# Regional Review Notification Development of Regional Impact

**Name of Proposal:** SRM Concrete Ready Mix Plant DRI 4487  
**Submitting Local Government:** City of McDonough  
**Date Opened:** November 7, 2025      **Comments Due:** November 22, 2025      **Date to Close:**

**Description:** *A DRI review of a proposal to construct a ready mix concrete plant including a small office, pump house, batching equipment, materials storage, weigh station / scales & wash rack, and parking and loading areas on a previously developed 3.3-acre site at 295 Racetrack Road in the City of McDonough in Henry County.*

PROPOSED SITE PLAN GRTA DRI# 4487

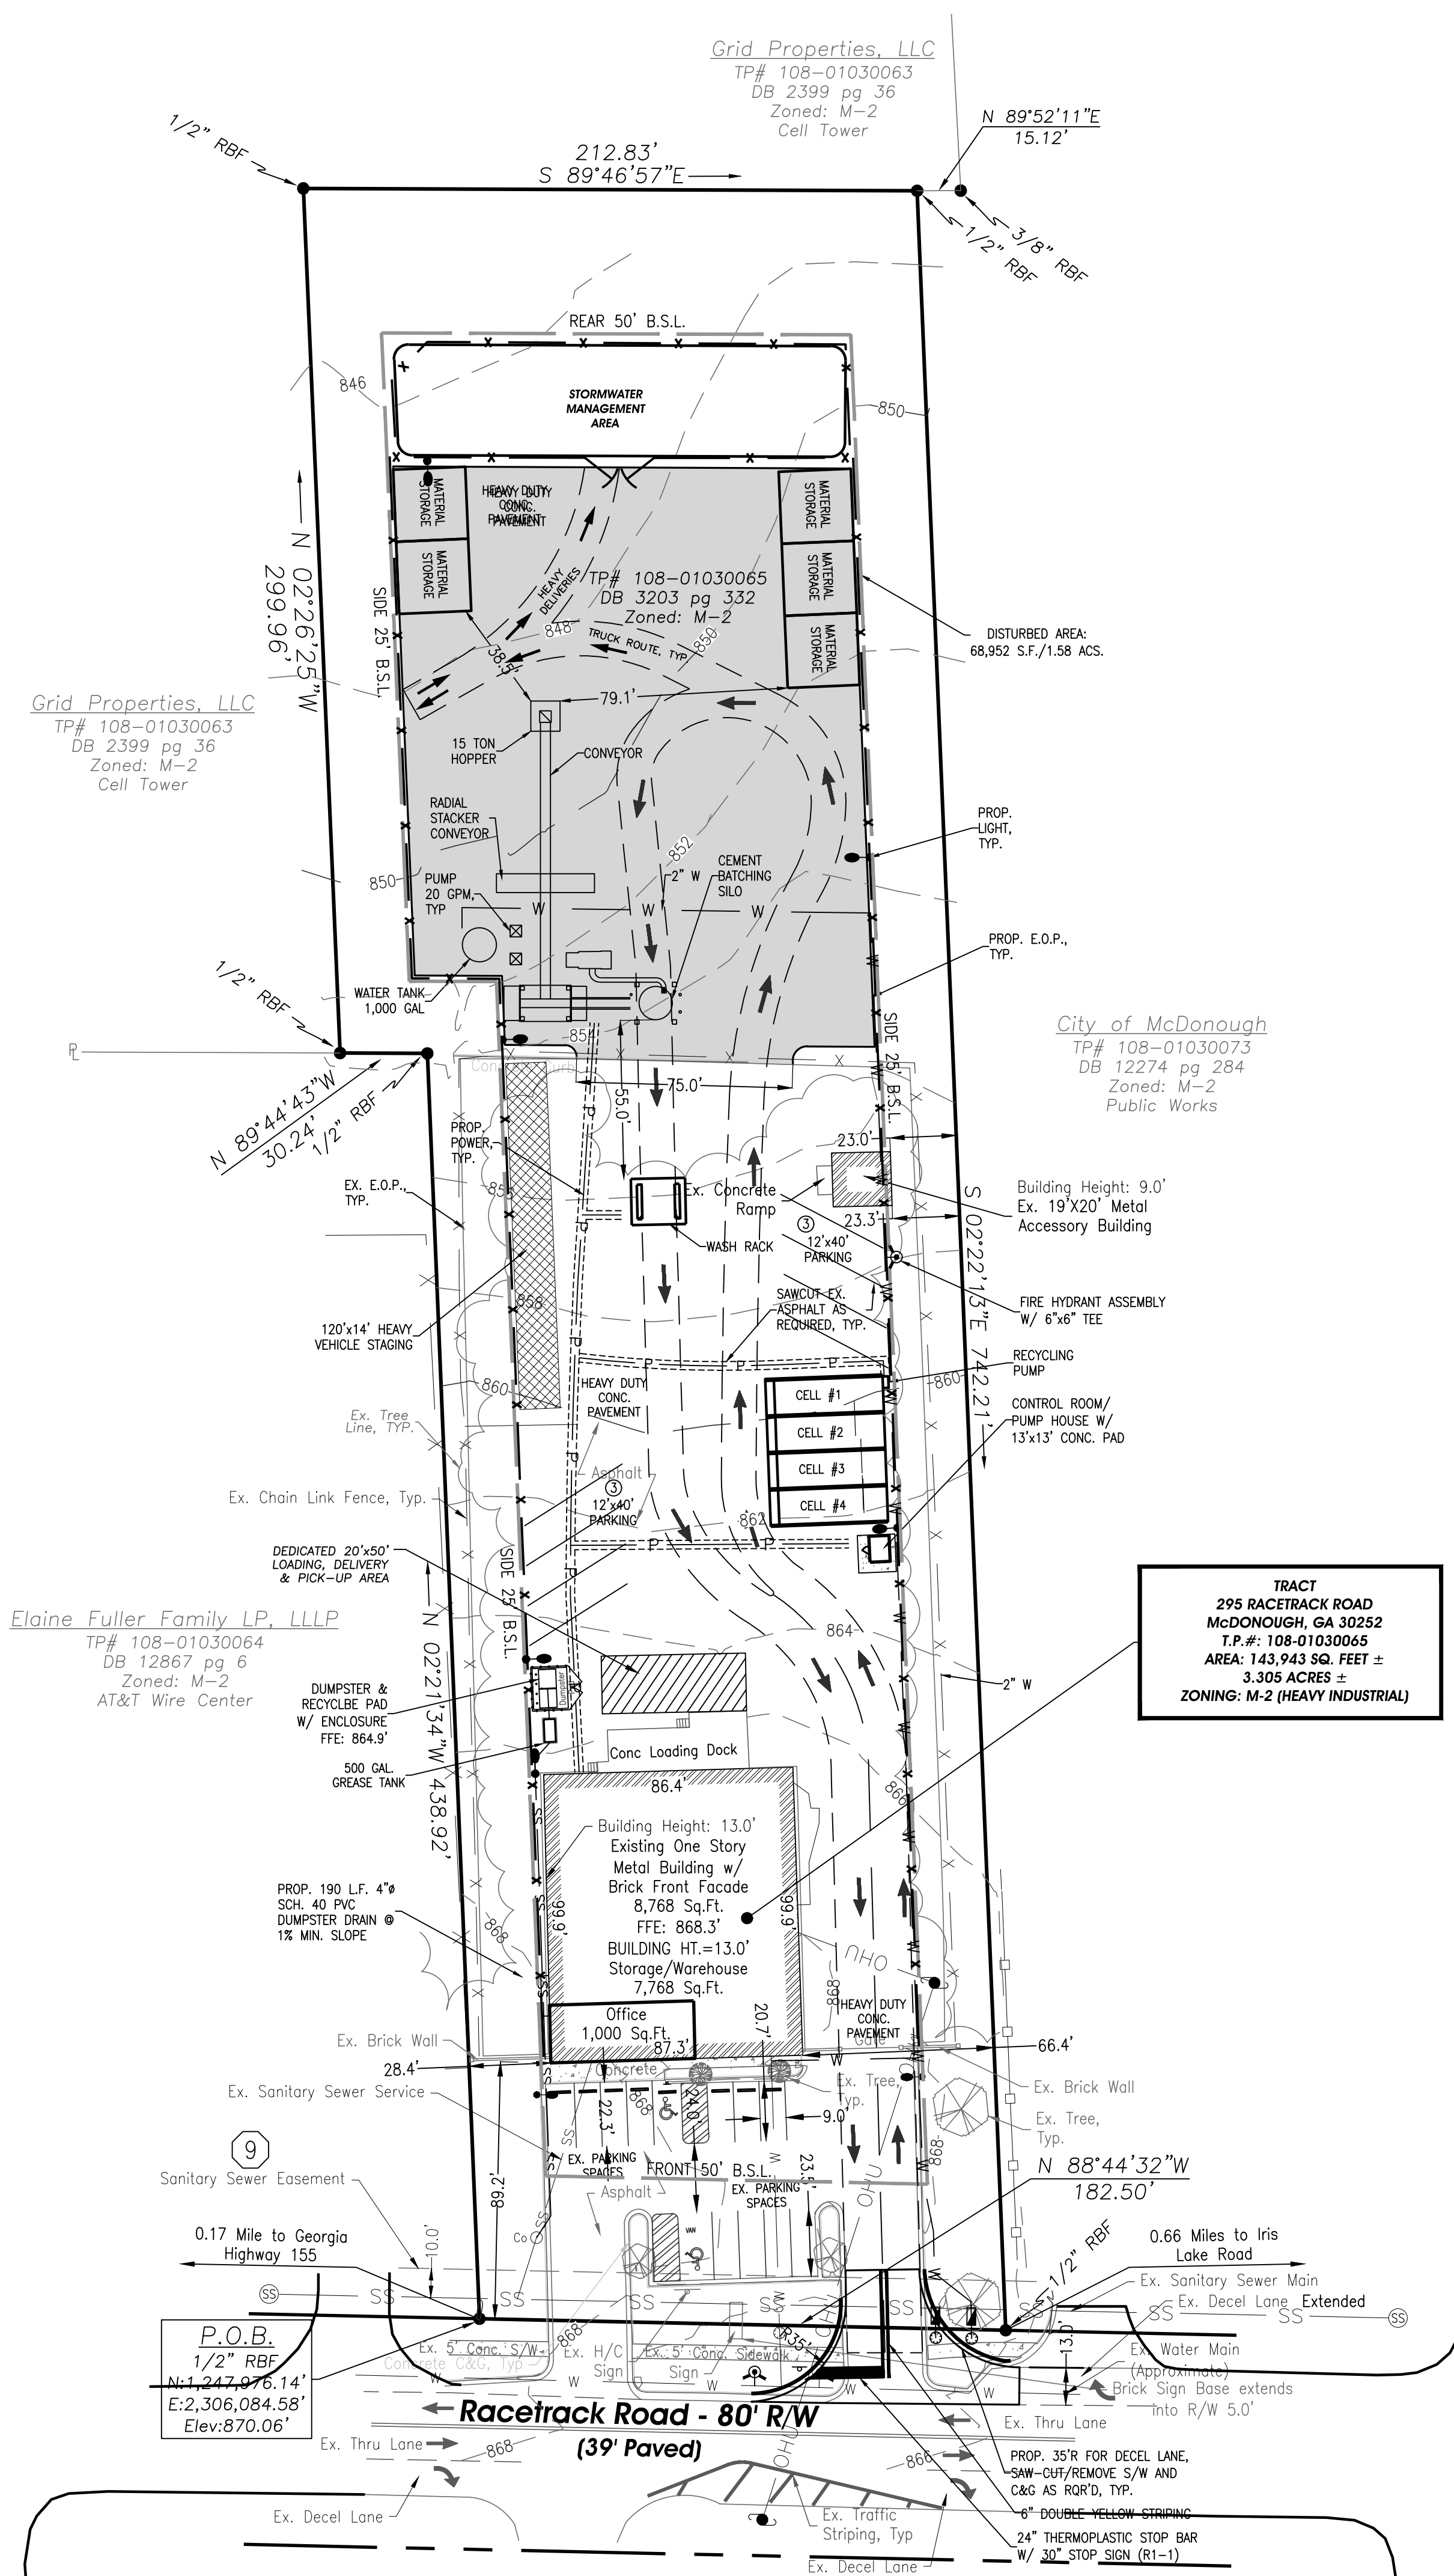
*It is recommended that the stormwater impacts be addressed through green infrastructure and other alternative elements to reduce the size of or eliminate the need for the proposed stormwater pond at the rear of the property and thereby increase the number of trees retained to provide a strong visual, sound, and dust buffer for the residential area to the north.*

It is recommended that the stormwater impacts be addressed through green infrastructure and other alternative elements to reduce the size of or eliminate the proposed stormwater pond at the rear of the property and thereby increase the number of trees retained to provide a strong visual, sound, and dust buffer for the residential area to the north.
